ADDENDUM NO. 2
SEWER SYSTEM IMPROVEMENTS
CONTRACT 17-01
MORNINGSIDE DRIVE 8-INCH FORCE MAIN
CHAPEL HILL, TENNESSEE
WAUFORD PROJECT NUMBER 2034
CDBG PROJECT NO. 11132

Date of Addendum: Thursday, July 5, 2018
Bid Opening: To Be Determined

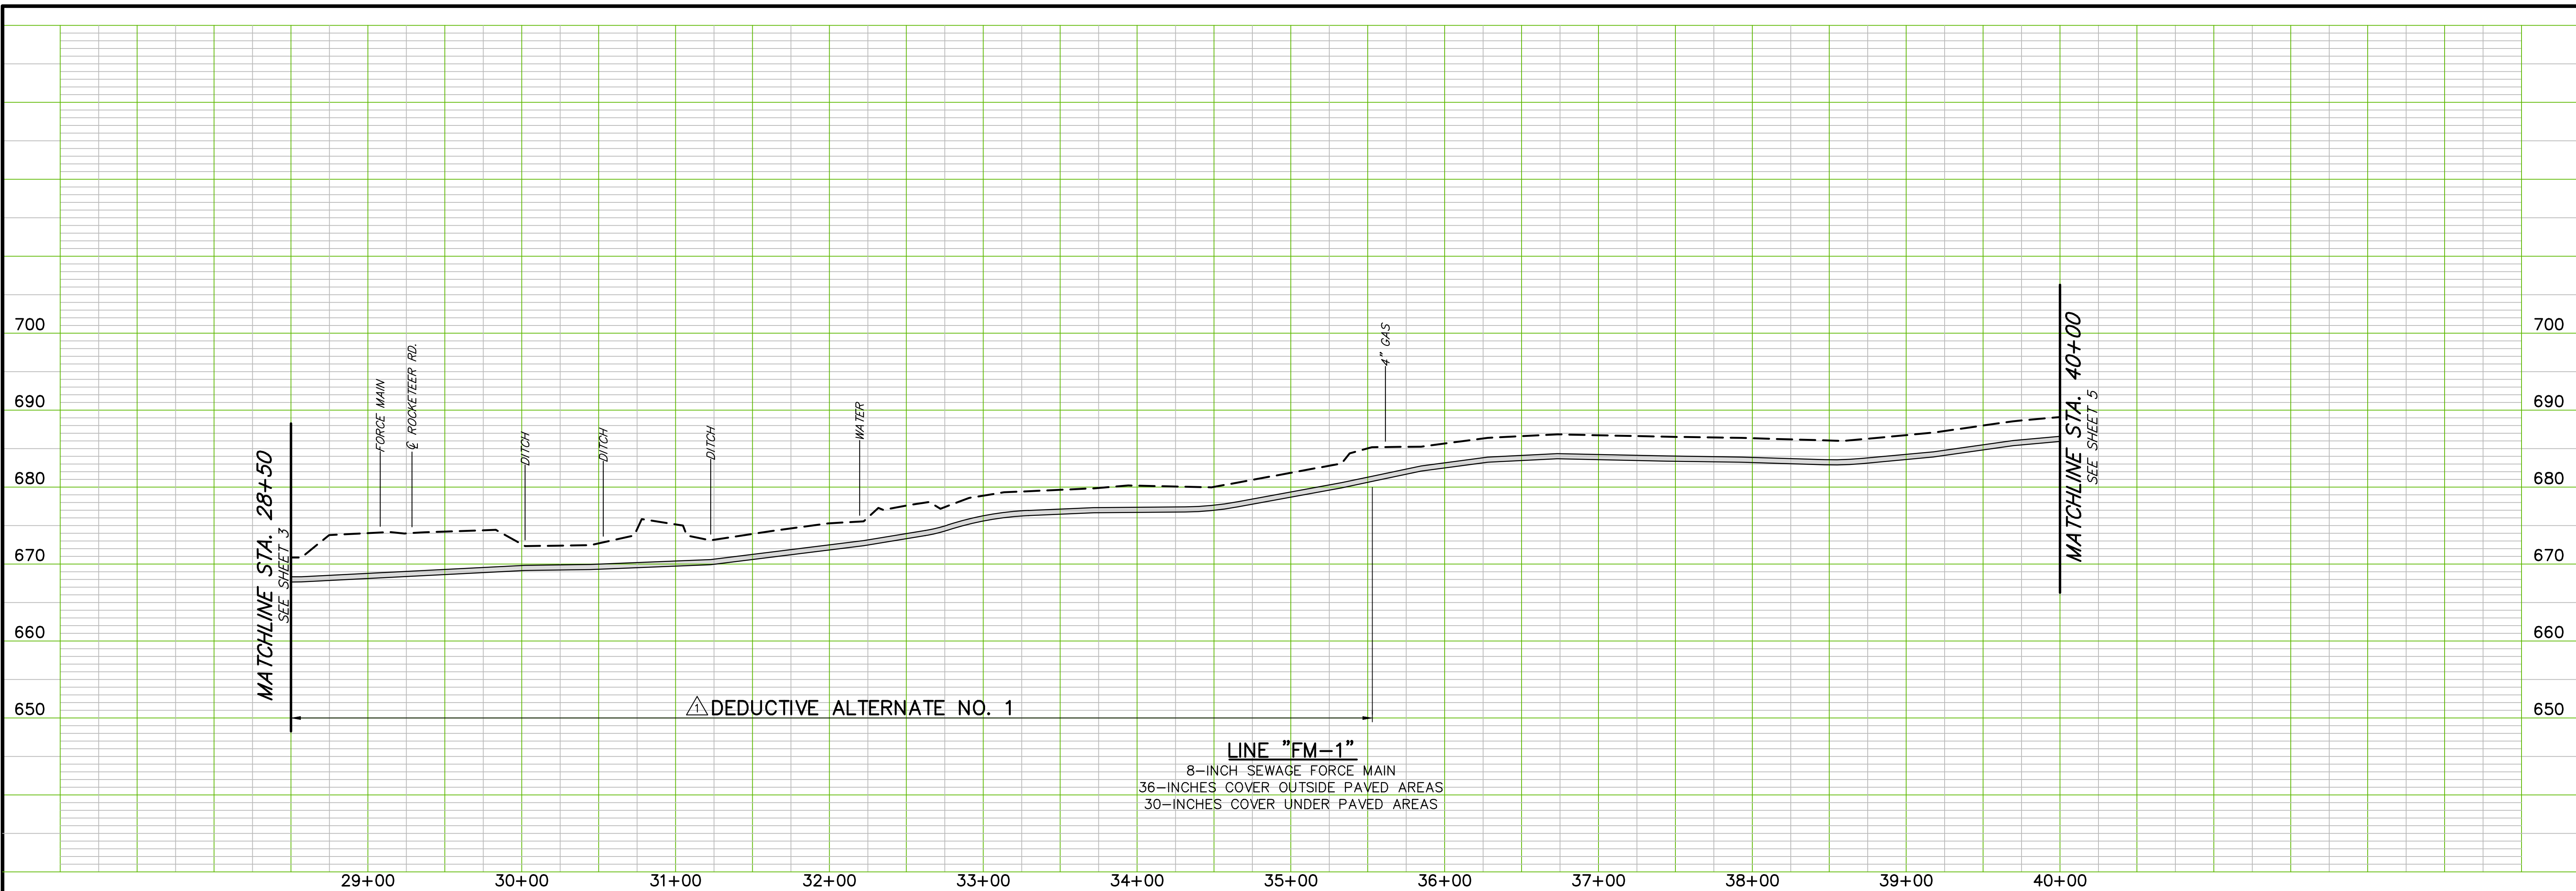
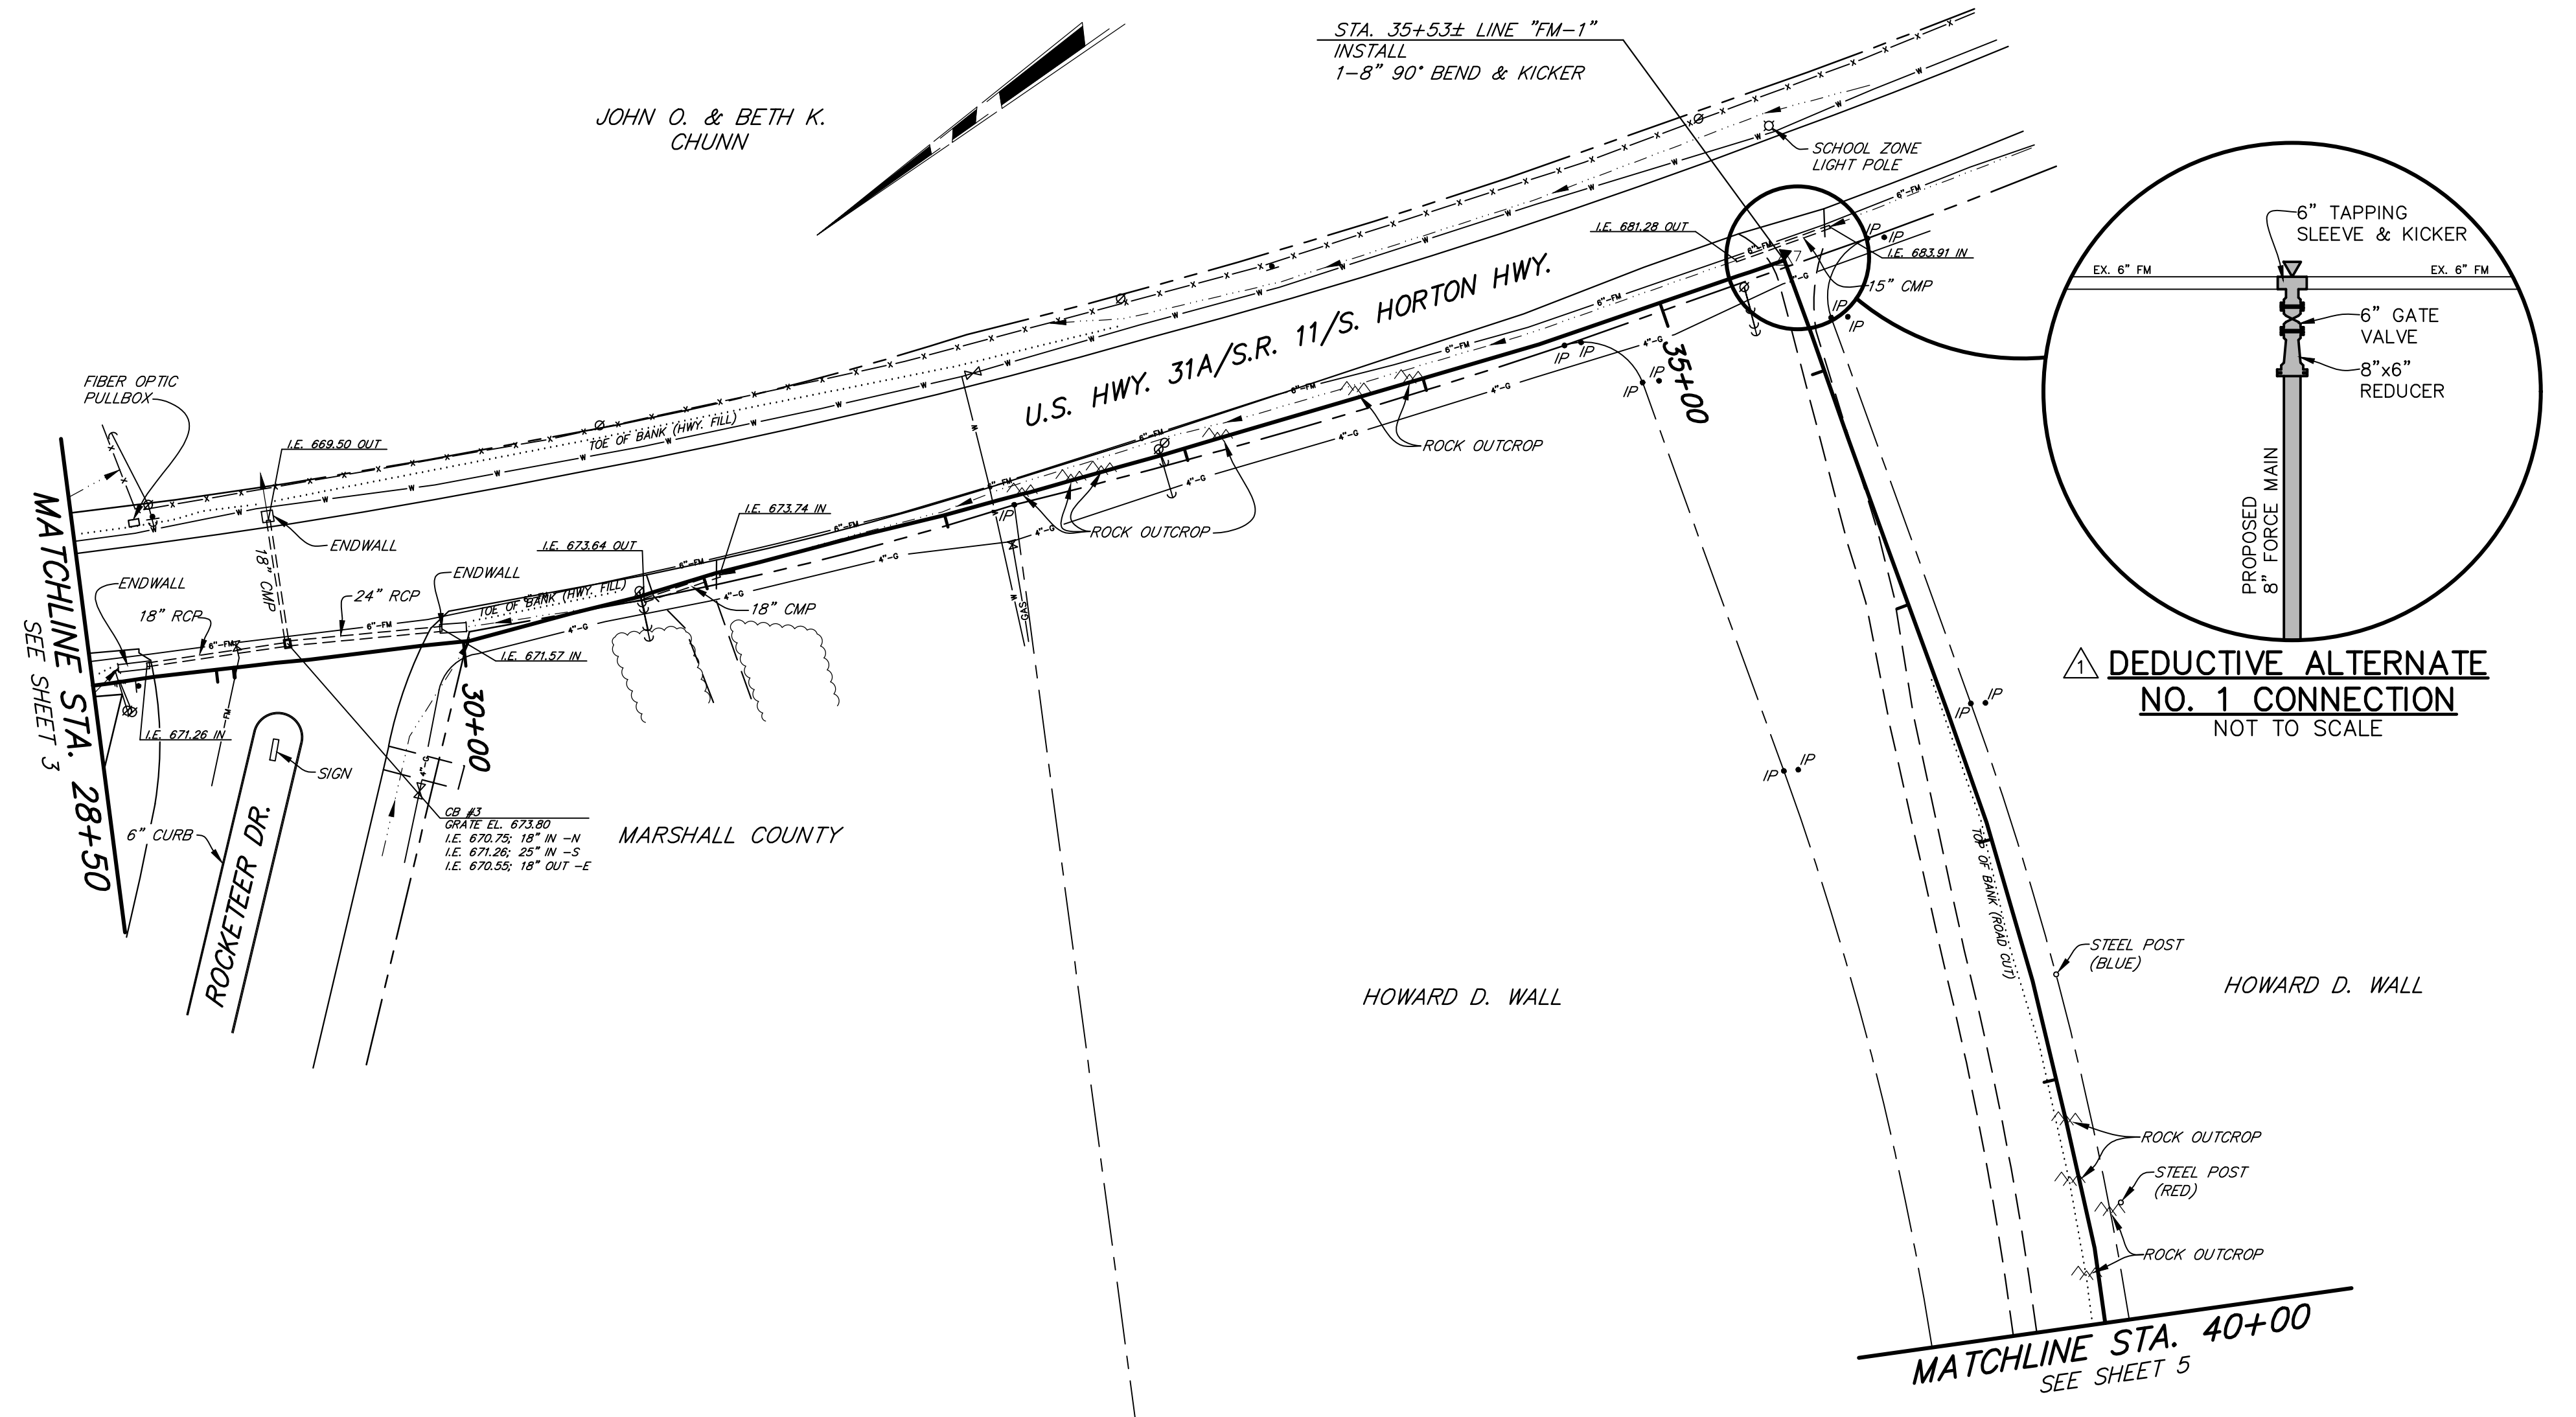
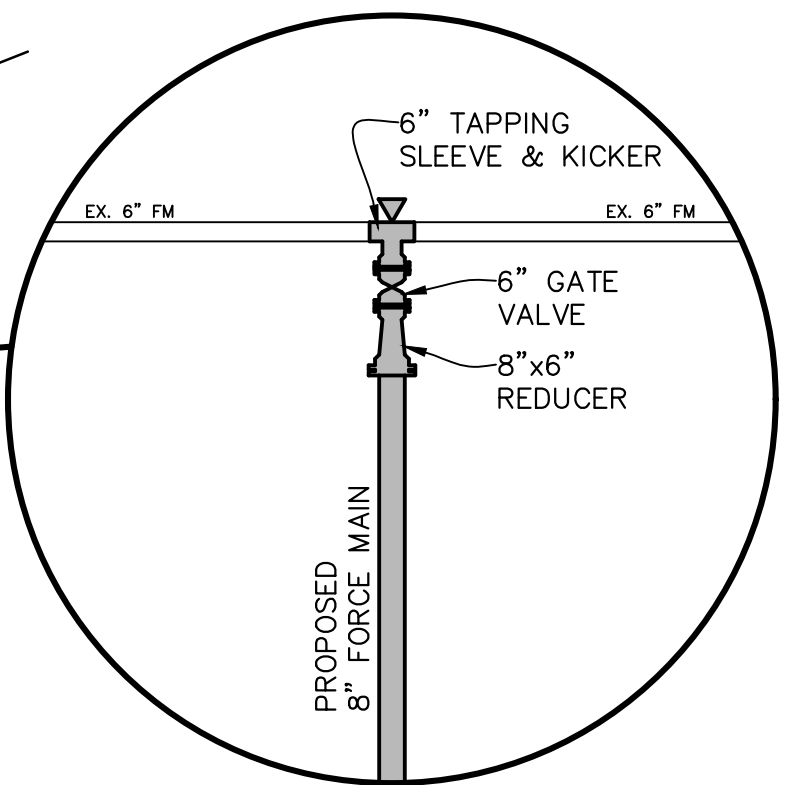
J. Gregory Davenport, P.E.
Tennessee License No. 104881

DEDUCTIVE ALTERNATE NO. 1 CONNECTION
 NOT TO SCALE

- CONSTRUCTION NOTES:**
- SEE "GENERAL NOTES" AND "LEGEND", SHEET 1.
 - ADDITIONAL DEPTH OF CUT BELOW 36-INCH DEPICTED ON THESE PLANS IS NOT A SEPARATE PAY ITEM.
 - NO UNIT PRICE PAYMENT WILL BE MADE FOR ITEMS INCLUDED IN THE LUMP SUM PRICE FOR CONNECTION NO. 2.
 - ALL FITTINGS SHALL UTILIZE RESTRAINT GLANDS EQUAL SERIES 1100 MEGALUG BY EBAA IRON, INC. AND CONCRETE KICKERS.
 - THE CONTRACTOR SHALL POTHOLE ALL EXISTING UTILITIES A MINIMUM OF 200 FEET PRIOR TO PIPE INSTALLATION TO AVOID CONFLICTS.
 - DEDUCTIVE ALTERNATE NO. 1 CONSISTS OF FORCE MAIN INSTALLATION FROM STA. 0+00 TO STA. 35+53±.
 - IF THE OWNER PROCEEDS WITH THIS PROJECT AND CHOOSES TO TAKE DEDUCTIVE ALTERNATE NO. 1, THE CONTRACTOR SHALL CONNECT THE EXISTING 6-INCH FORCE MAIN TO THE NEW 8-INCH FORCE MAIN AT APPROXIMATE STA. 35+53± AS SHOWN ON THE PLANS. NO ADDITIONAL PAYMENT WILL BE MADE FOR THIS CONNECTION.
